NEDO-24011-A, Revision 30,  
General Electric Standard Application for Reactor Fuel  
(GESTAR II, US Supplement), April 2020

**General Electric Standard Application  
for Reactor Fuel**

**(Supplement for United States)**

Figure S-6. Scenario 2 Krypton Whole Body Dose with Respect to Charcoal Hold Up

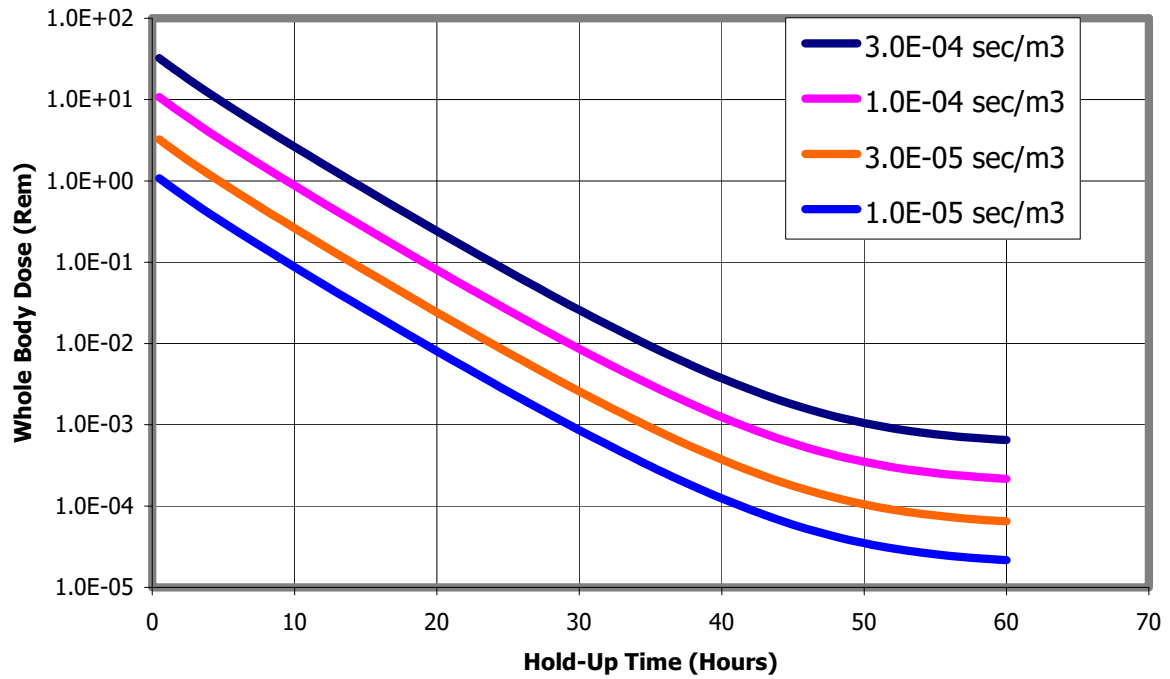
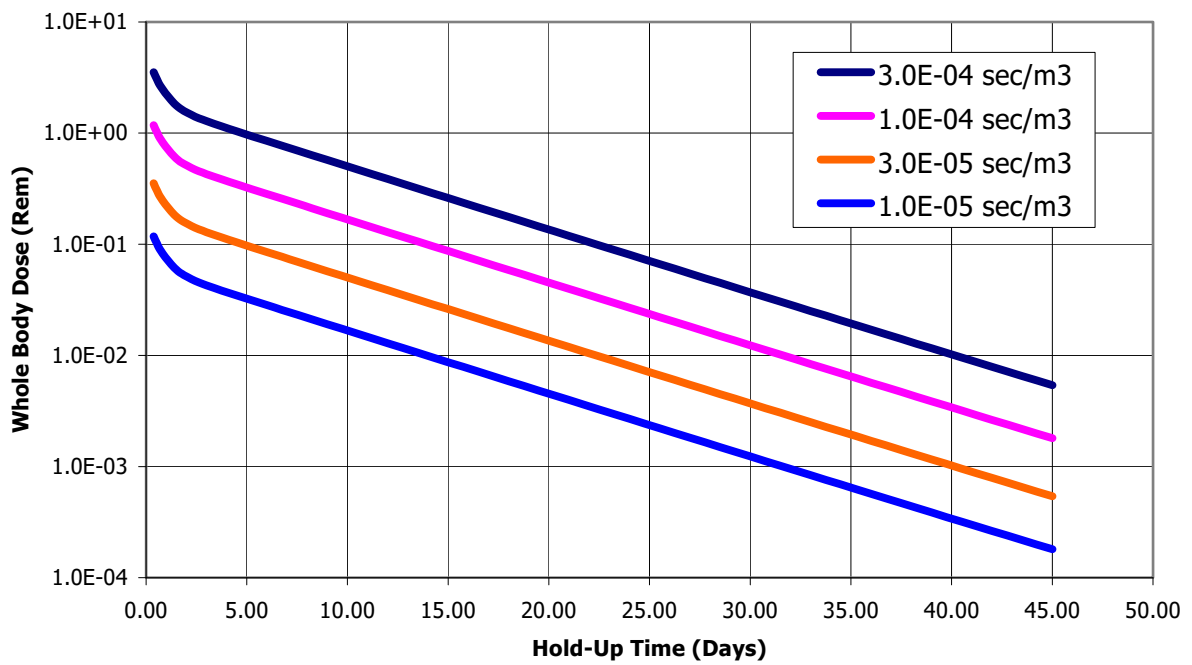
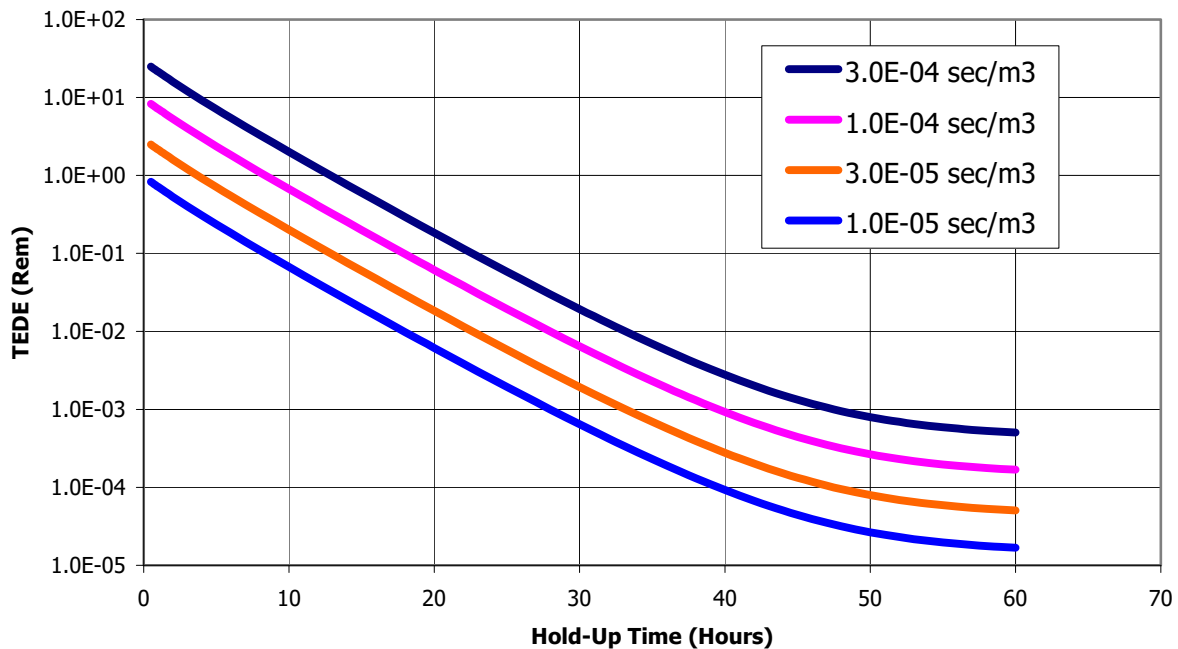
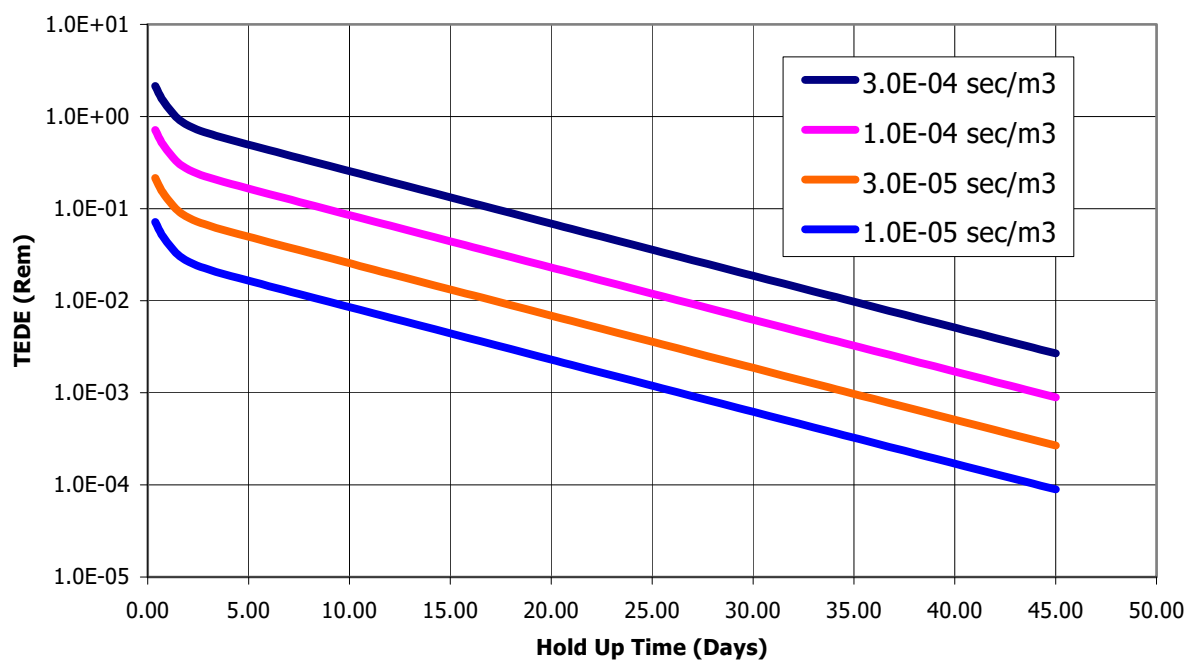
- For accident Scenario 2, please provide the amount of fission products released from the offgas system, resulting doses, and relevant dose calculations for several representative charcoal holdup times in Figures B-2, B-3, B-5, and B-6 of Attachment B.

A sample calculation is provided to show how the curves in Attachment B Figures B-2 and B-3 were generated. The dose conversion factors that were used are as follows:

The resulting Kr whole body dose for a X/Q of 1.0E-04 sec/m<sup>3</sup> and an offgas holdup time of 40 hours is 1.24E-03 Rem, which is consistent with the applicable curve in Attachment B Figure B-2.

The resulting Xe whole body dose for a X/Q of  $3.0\text{E-}04 \text{ sec/m}^3$  and an offgas holdup time of 40 days is  $1.02\text{E-}02 \text{ Rem}$ , which is consistent with the applicable curve in Attachment B Figure B-3.

The resulting Kr TEDE dose for a X/Q of 1.0E-04 sec/m<sup>3</sup> and an offgas holdup time of 40 hours is 9.24E-04 Rem, which is consistent with the applicable curve in Attachment B Figure B-5.

The resulting Xe TEDE dose for a X/Q of 3.0E-04 sec/m<sup>3</sup> and an offgas holdup time of 35 days is 9.75E-03 Rem, which is consistent with the applicable curve in Attachment B Figure B-6.

**Figure 5.2-1. Effects of Initial MCPR on  $\Delta$ CPR Typical BWR Core**

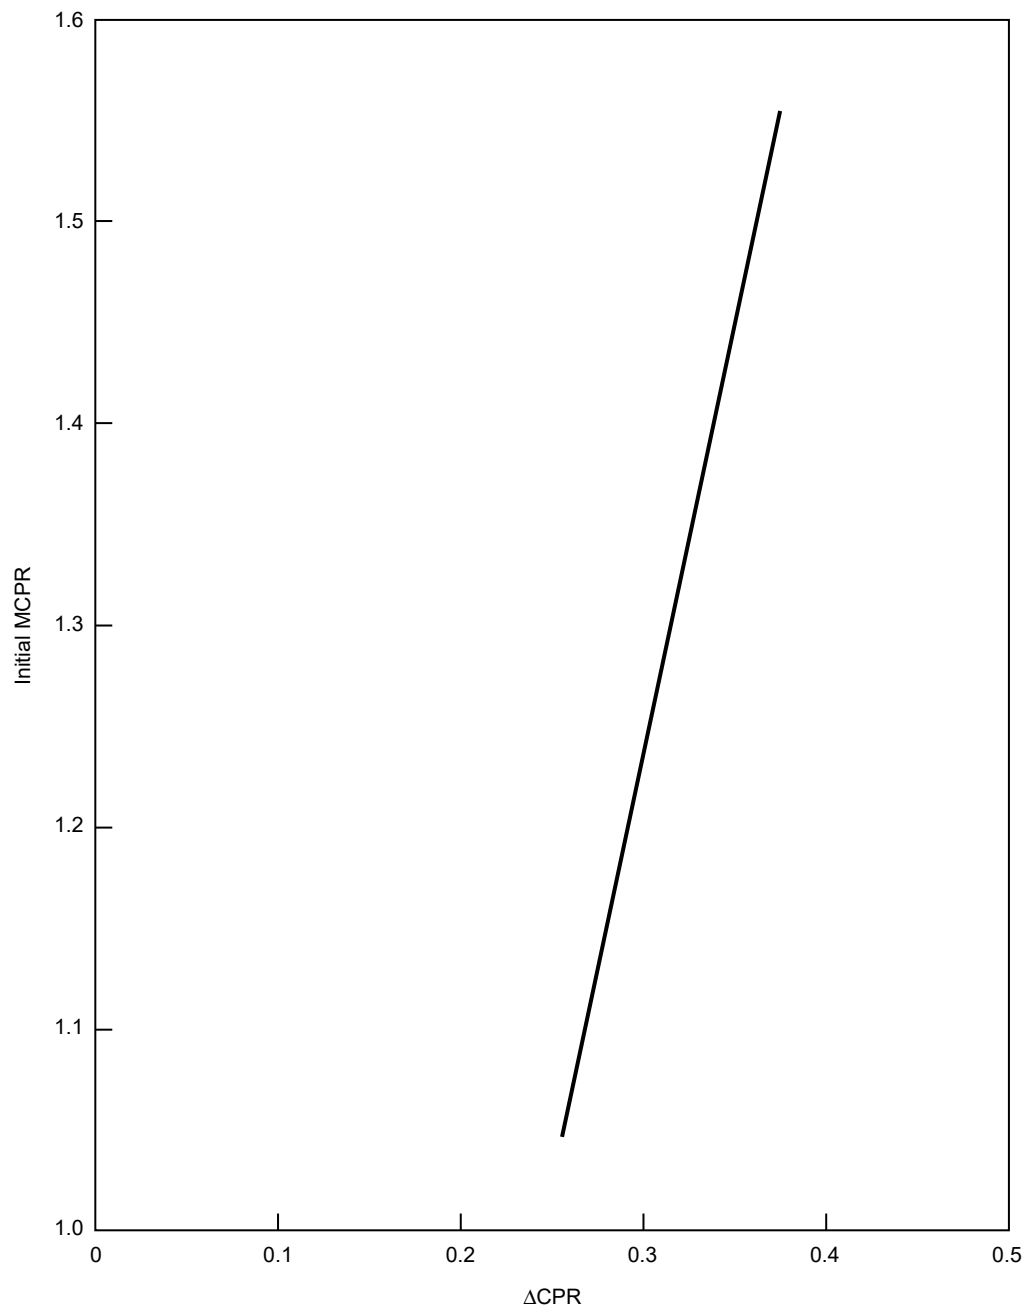
Based on Figure 5.2-1 in Appendix B on page US-6 under S.2.2.1, it appears that the change in  $\Delta\text{CPR}$  versus initial MCPR may be 0.1 versus 0.5 not .01 versus 0.05. Please clarify that the statement is still valid when the change in  $\Delta\text{CPR}$  is approximately 0.01 for 0.05 change in initial MCPR based on Figure 5.2-1 in Appendix B.

Figure 5.2-1 and the associated text in Appendix B of GESTAR II was generated to address an RAI on GESTAR II, Revision 5.

The specific response addressed the transient  $\Delta\text{CPR}$  process and the initial MCPR assumption. Figure 5.2-1 and the discussion in GESTAR show the relative insensitivity of the  $\Delta\text{CPR}$  to the initial MCPR assumption. This figure does indicate approximately a 0.01 change in  $\Delta\text{CPR}$  for a 0.05 change in initial MCPR. The transient analysis process iterates the hot bundle power to achieve an initial MCPR such that the minimum CPR during the transient reaches the SLMCPR. In other words, the limiting transient could start at the OLMCPR and the minimum CPR would be the SLMCPR. Transients that are less severe have lower  $\Delta\text{CPR}$ s, therefore, the initial MCPR in the transient needs to be lower for the transient minimum to reach the SLMCPR. The main point of the original response is to describe that starting non-limiting transients at a lower initial MCPR is acceptable because of the small impact to the  $\Delta\text{CPR}$ . A non-limiting transient can begin the transient at a CPR less than the OLMCPR and have a minimum CPR above the SLMCPR.

Figure 5.2-3.  $K_f$  Factor

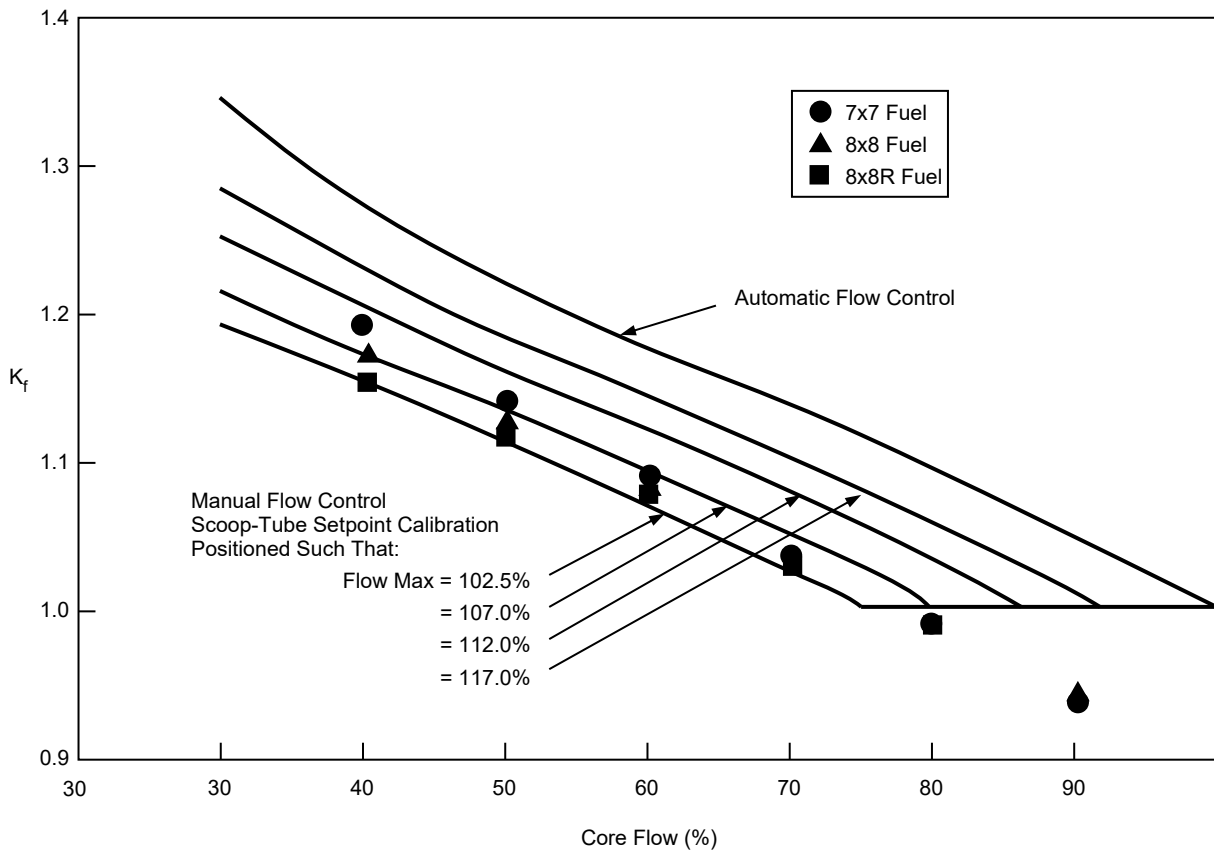
The brief paragraphs, which discuss the operating limit MCPR/low flow correction curves,  $K_F$ , for reduced core flow conditions, do not adequately describe the basis for the construction of the generic curves shown in Figure 5-7. A substantially more detailed discussion of the procedure employed is required. Describe the models, methods and assumptions used, which make the curves generic for BWR/2, BWR/3 and BWR/4 plants incorporating up to three different fuel designs. Either justify why the new fuel design (8x8R) is conservatively bounded by the analysis or provide an additional thermal hydraulic analysis to demonstrate that the indicated curves are bounding. Clearly state the criteria used for developing the curves for the automatic and manual flow control modes.

Figure 5.2-3 compares the derived 102.5% core flow  $K_f$  curve with the standard curves (Figure 5-7). These results show that the 8x8R fuel closely follows the 102.5% line, but the 7x7 fuel is 3.3% nonconservative at 40% core flow. However, the  $K_f$  curves are conservative for all cores with 7x7 operating limits greater than 1.23.

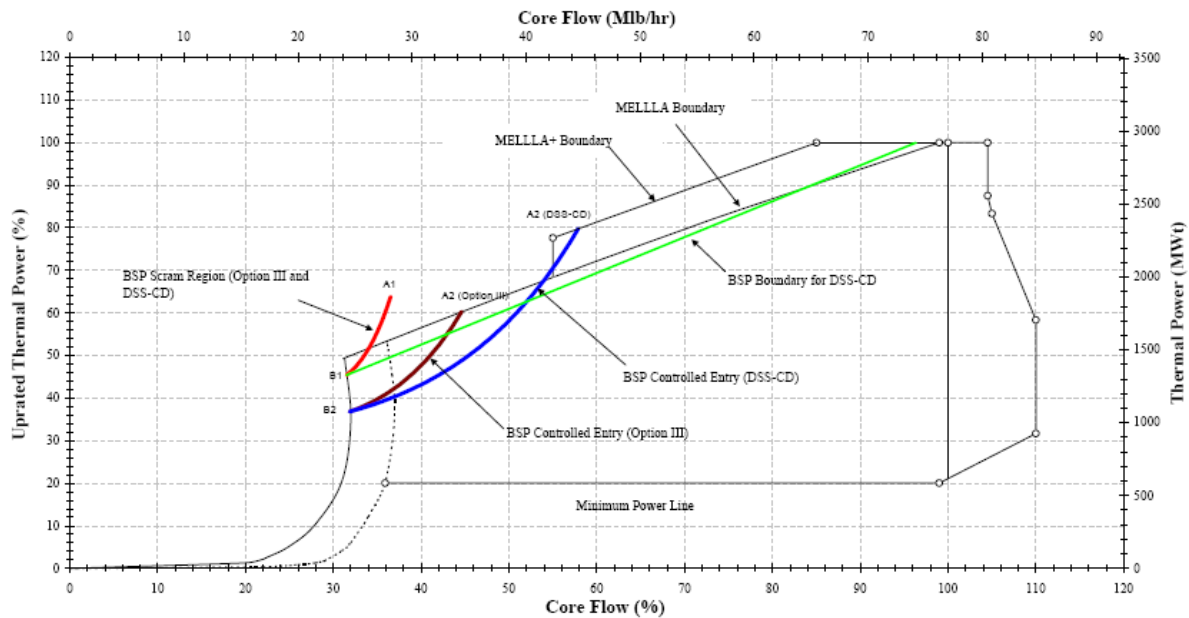
Please provide a power/flow map to show the difference of the domain for Backup Stability Protection (BSP) for DSS-CD under S.4.2.3 and Backup Stability Protection (BSP) for Option III under S.4.2.2, and describe what role Reference S-103 plays to generate a defined exclusion regions.

The calculated stability region boundaries for BSP for DSS-CD and BSP for Option III are shown in the figure below. Please note that the actual implemented BSP boundaries might be larger due to the Base BSP region definitions.

These two BSP methodologies are very similar between the two long-term stability solutions of Option III and DSS-CD. However, two differences exist:
